Your Ref
AW/166/17/PL
Our Ref
PLAN-019061
Date
09/08/2017

Proposal: Change of use from bed & breakfast (C1 Hotel) to (C2 Residential Institutions).
Site: Swan Guest House, 17 Nyewood Lane, Aldwick, PO21 2QB.
AW/166/17/PL

SOUTHERN WATER

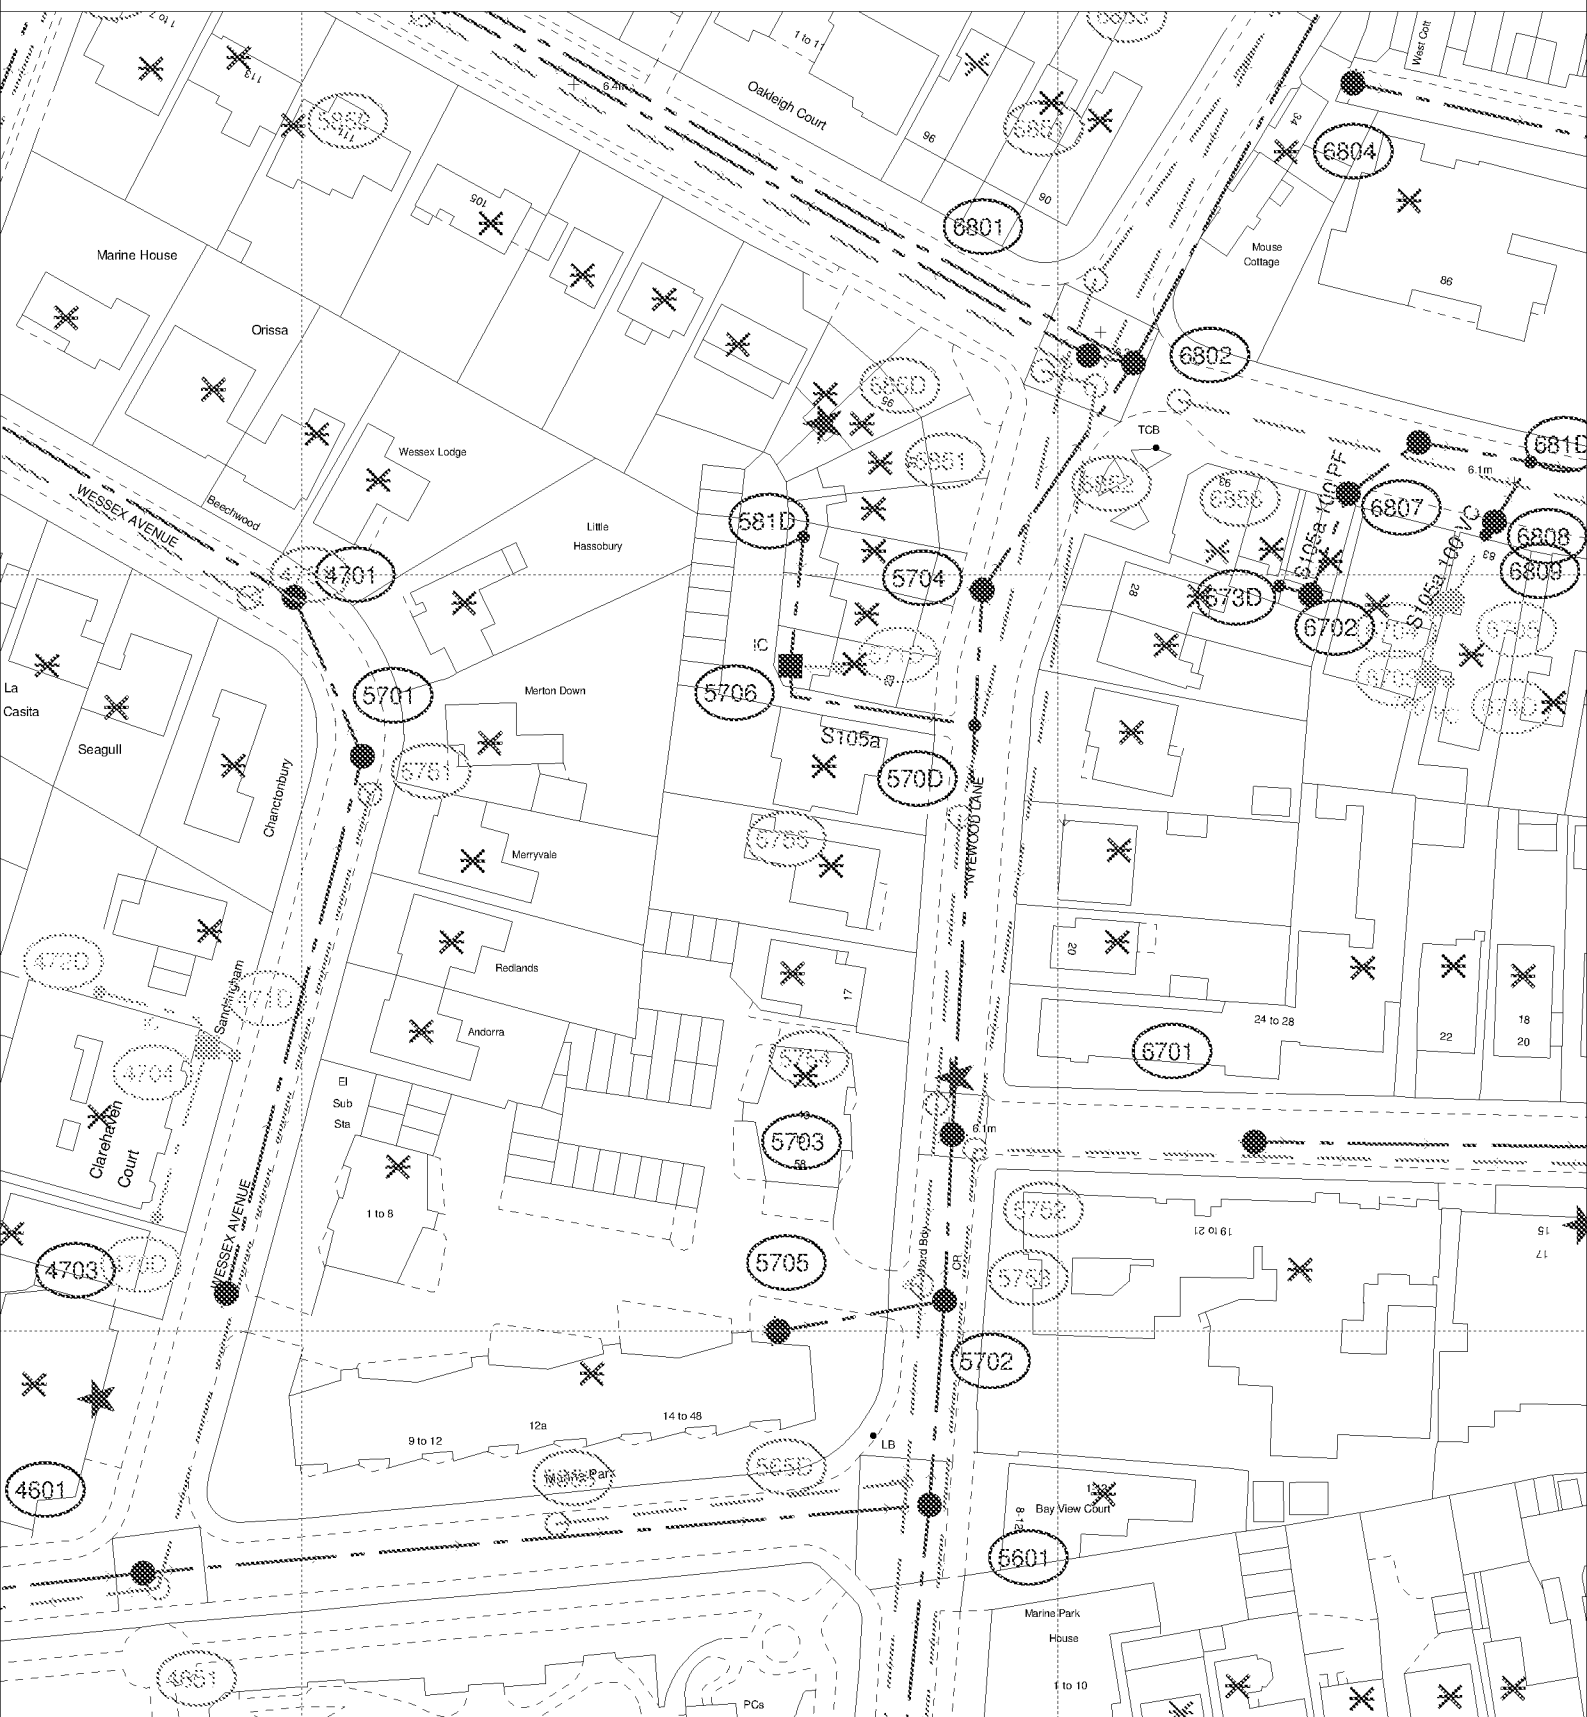
Thank you for your letter of 07/07/2017. Please find attached a plan of the sewer records showing the approximate position of public sewers in the vicinity of the site.
